**Subject:** EX: RE: Petition 4620 - TPE IL KN415 LLC Seeking Special Use for a Solar Array

TPE IL KN415, LLC  
KANE COUNTY, IL

ZONING SITE  
PLAN

SHEET NUMBER  
EX-1

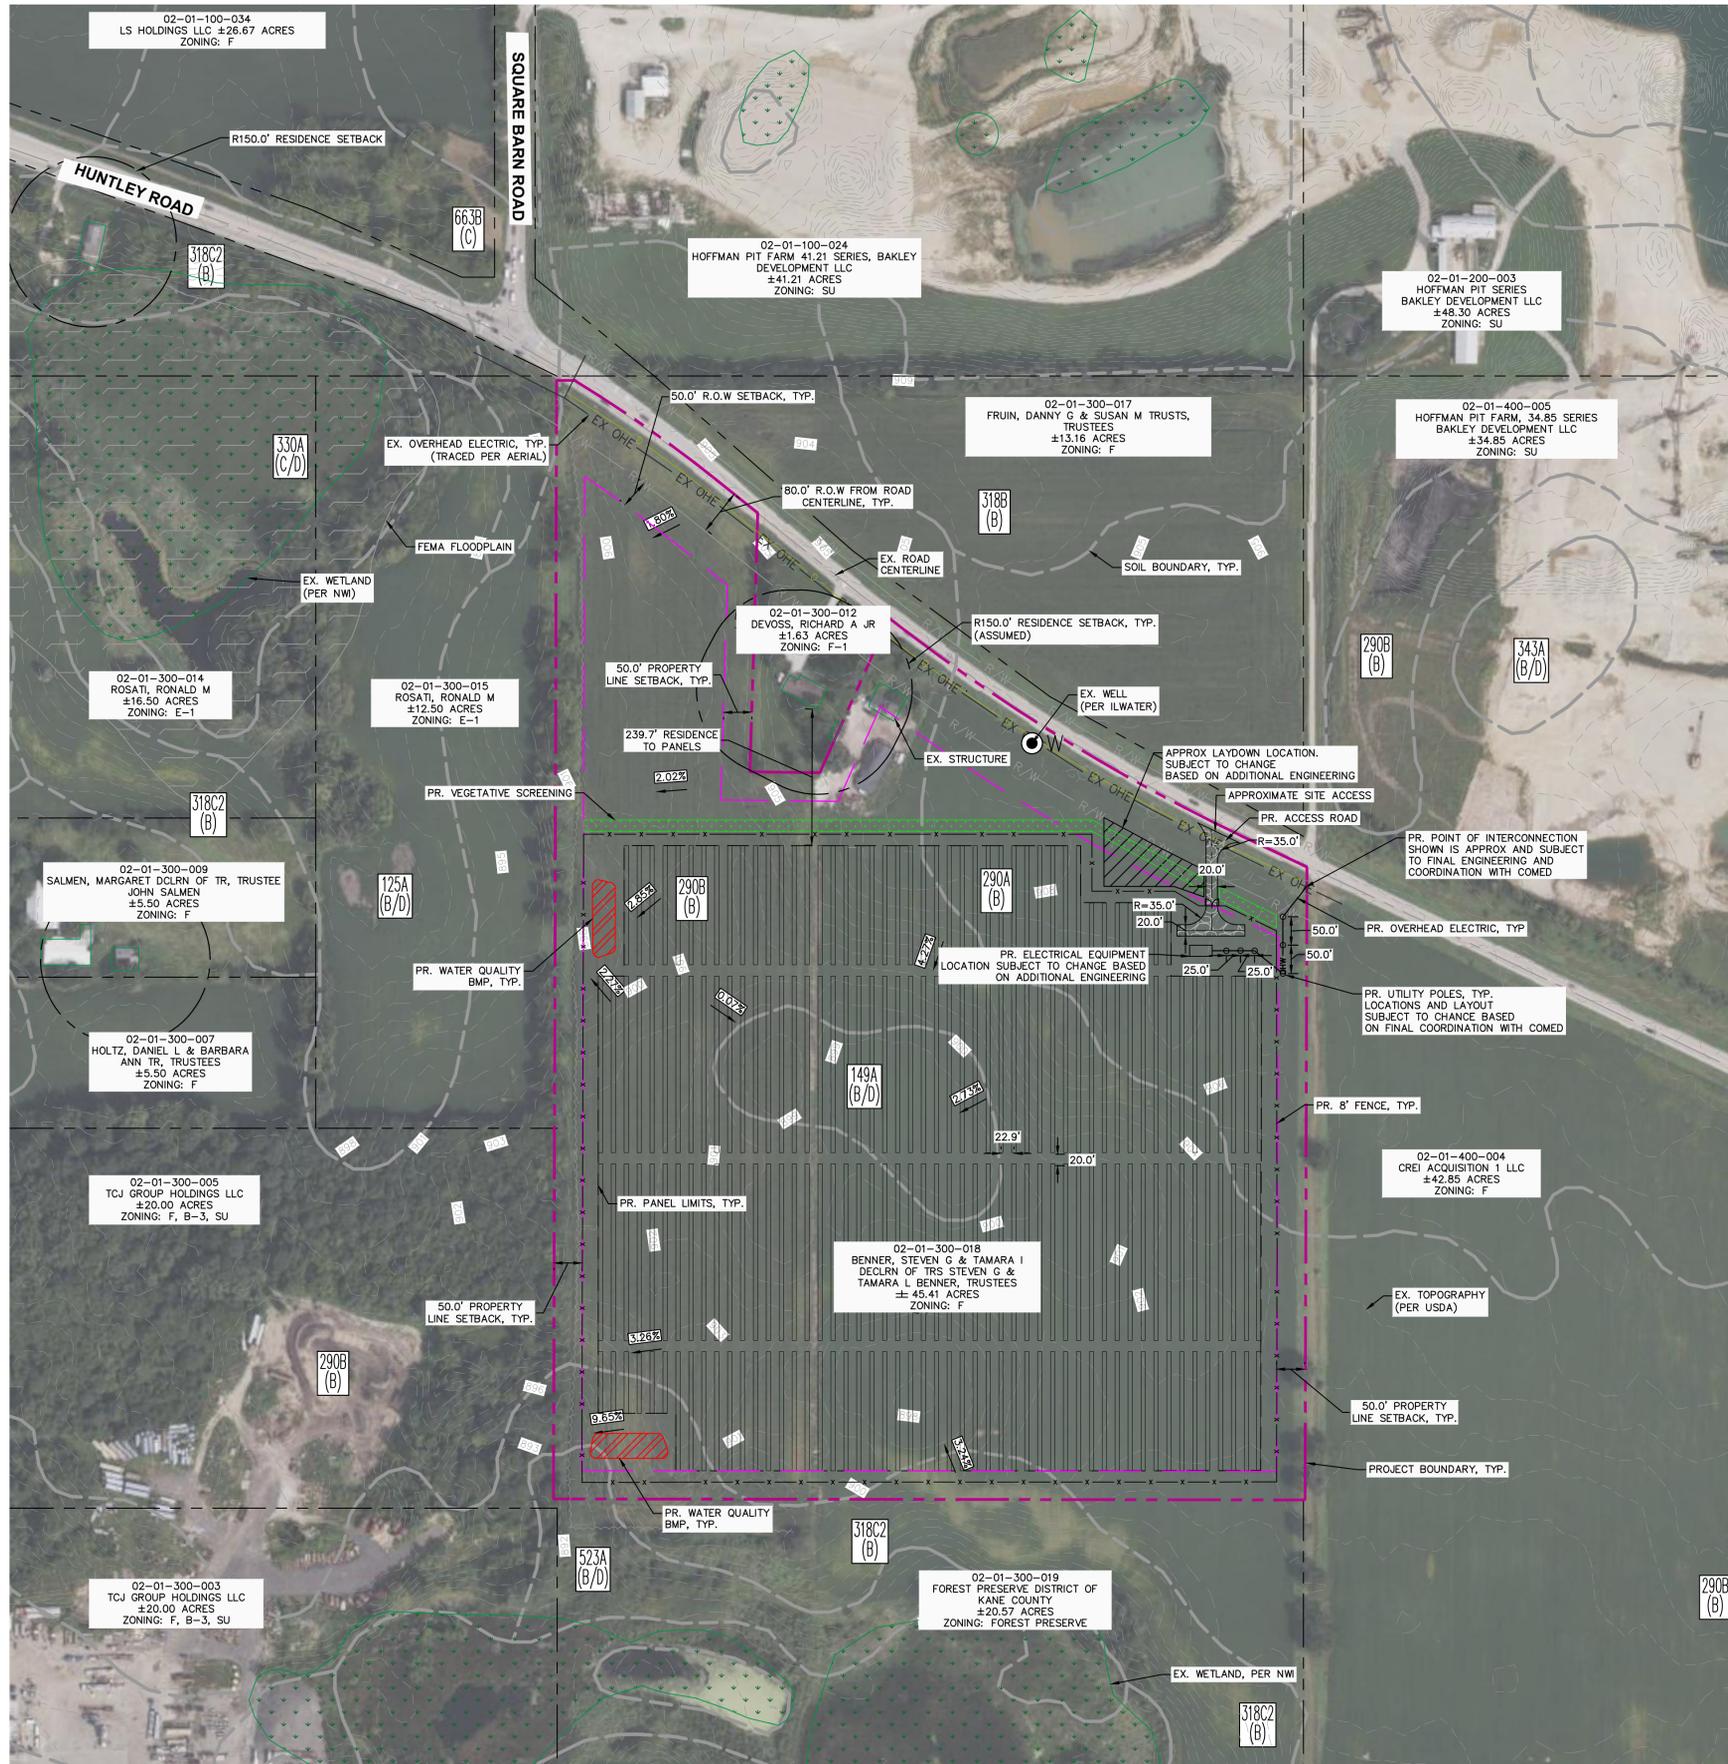
In response to the comments from KDOT and Algonquin regarding the future Huntley Road Expansion, we have drafted the attached revised zoning site plan. Please note the grey "R/W" line depicted south of Huntley Road is 80' off the centerline for Huntley Road. The yellow line shown parallel to Huntley is a gas line identified in our surveys, We added it for reference as a reminder that we will need a crossing agreement from its owner. The three above ground power poles to the east of the outlined project area will be ComEd's poles required for interconnection; we have placed them such that they are outside of the future Huntley expansion area.
